**COUNTY OF VENTURA
PUBLIC WORKS AGENCY**

Addendum No.1

Subject: **tšumaš Creek Improvements Hueneme Road to Upstream of Jane Drive.
Specification No. WP21-01; Project No.: 82323
Bids to be Opened Thursday, October 15, at 2:00 PM**

SUBDRAIN SYSTEM (L - 14 - 22)

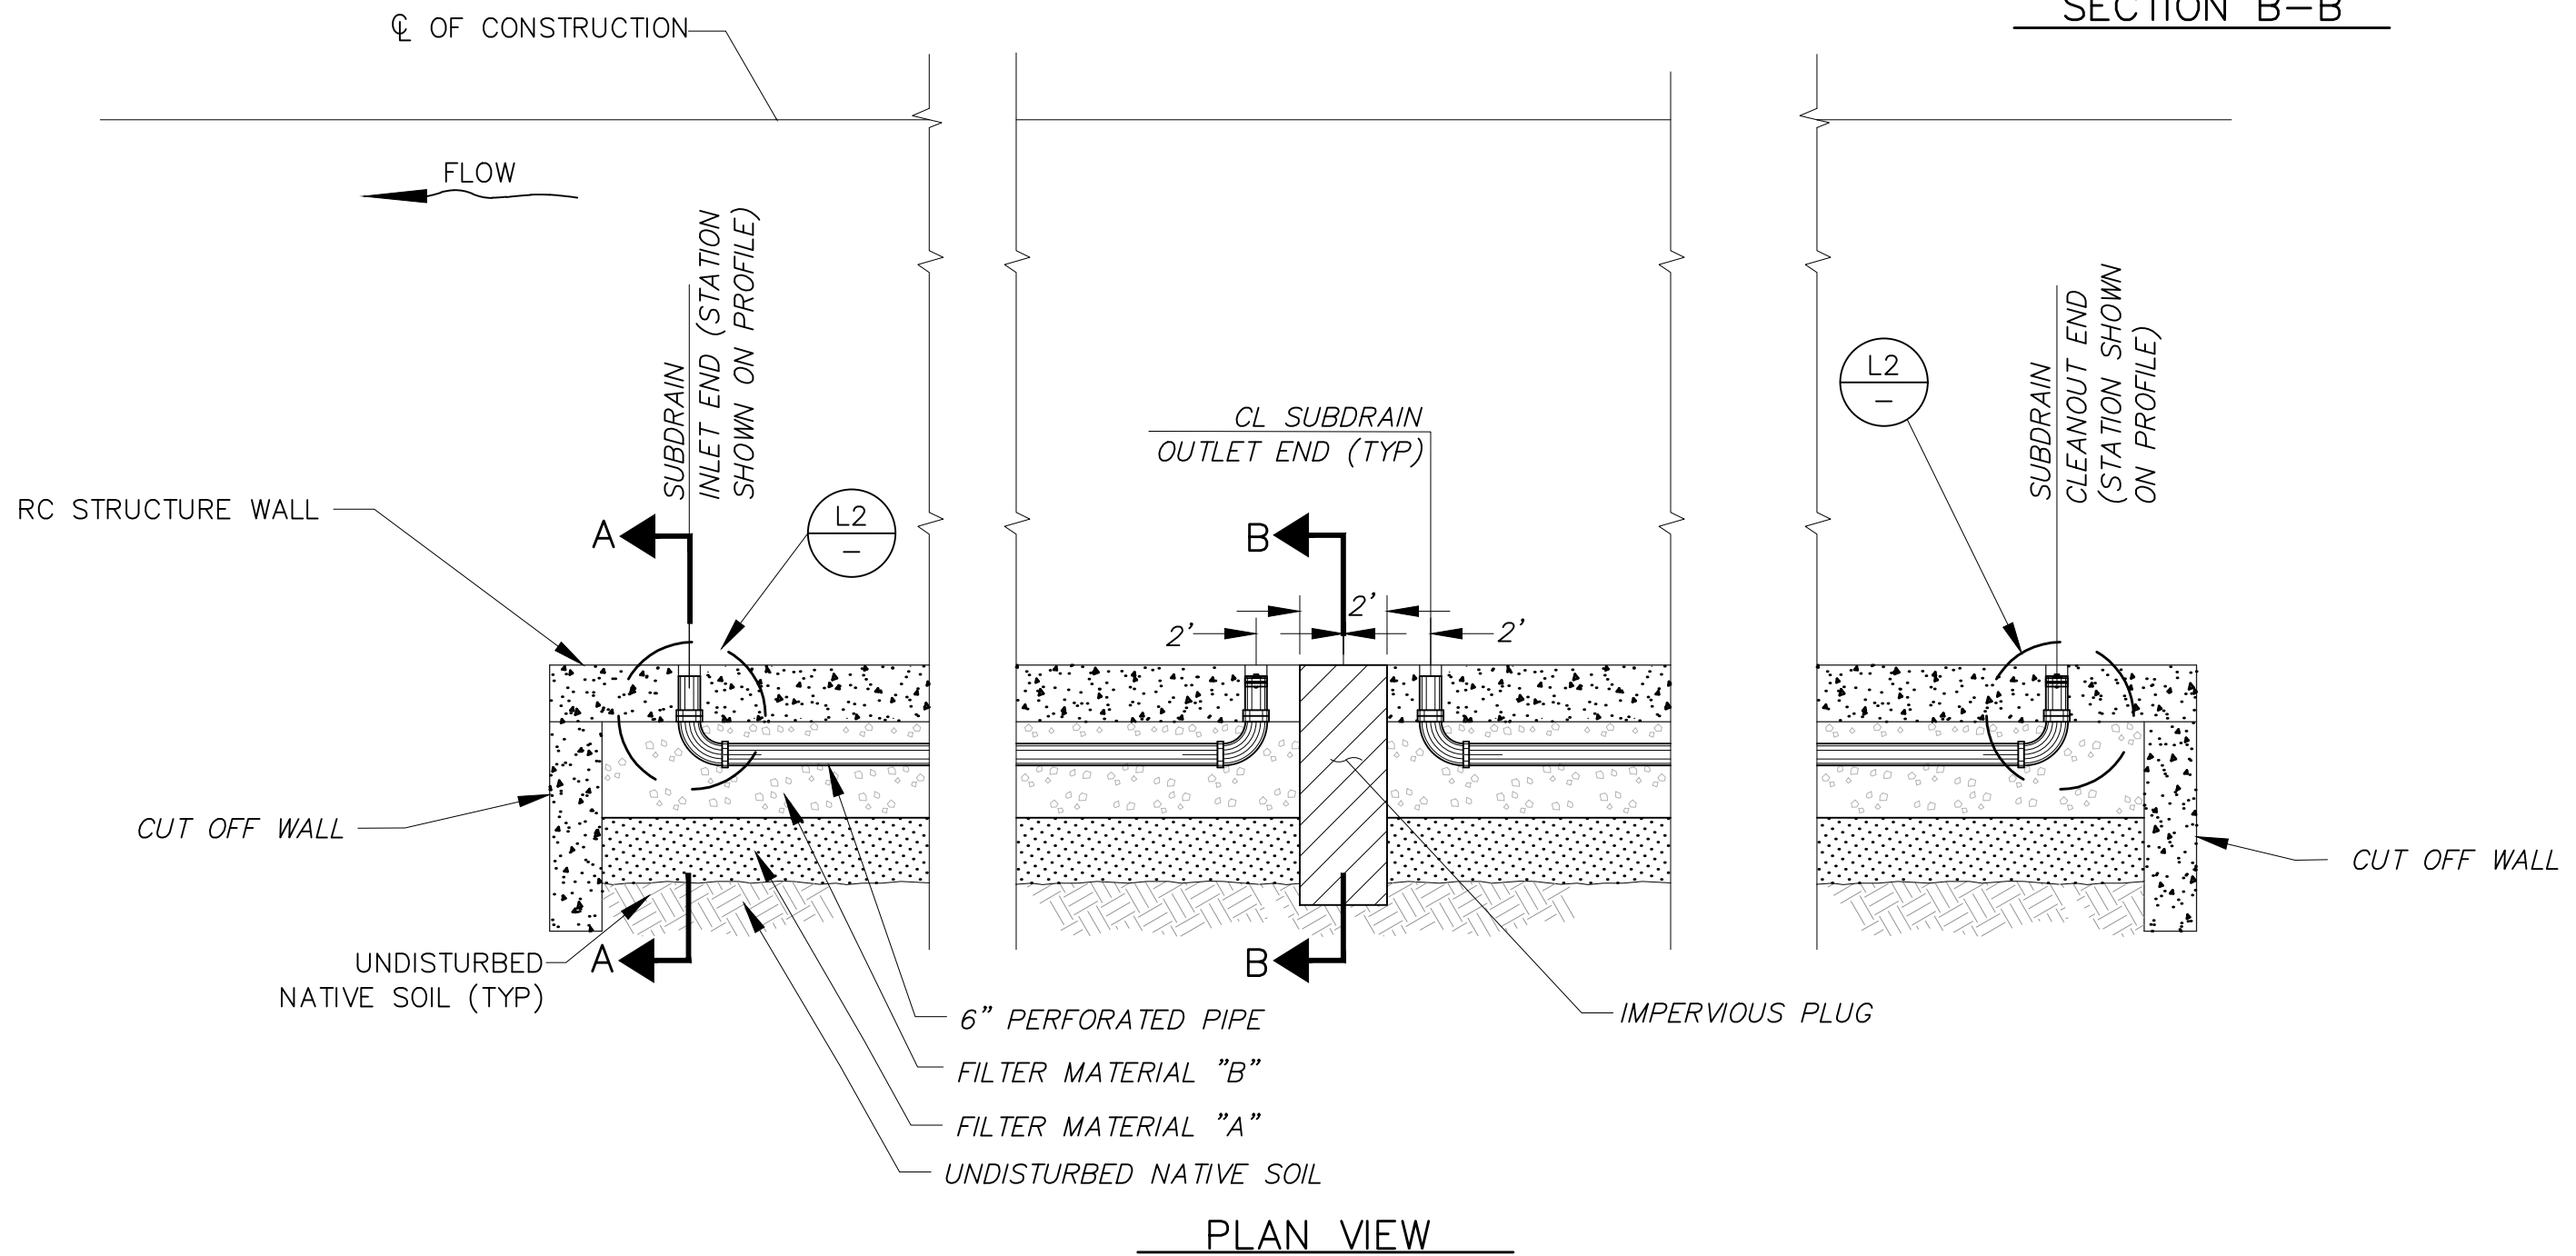
8. Replace sheet 11 OF 30, "SUBDRAIN DETAILS" with the attached, revised sheet 11 OF 30 to update the subdrain detail.
9. Replace sheet 24 OF 30, "CROSS SECTIONS STA 33+50 TO 37+00" with the attached, revised sheet 24 OF 30 to update with the new subdrain detail.
